Access Compliance Report Public Rights-of-Way (Pedestrian Signals)

Main Street: **MADISON_AVE** Cross Street: **NEWLAND_ST** Location: **SE**

ADA ID: **SGRK210929123712** Signal Type: **One Push Button-Non APS** Overall Compliance: **No** Severity Scores: **BTN 1: 35** **BTN 2: N/A** **No BTN: N/A**

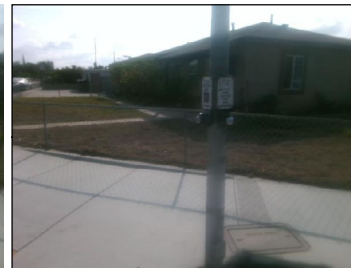
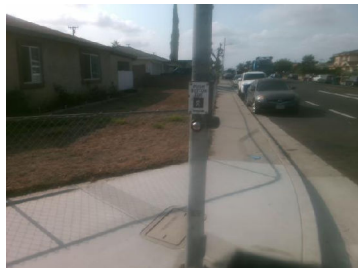
Surveyor Notes: Button 2 for Bike Lane

OC Std/PROW: R404.2, R404.3, MUTCD 4e.08

Possible Solutions: Replace Signal Push Button With APS Button. Remove and Replace Clear Space.
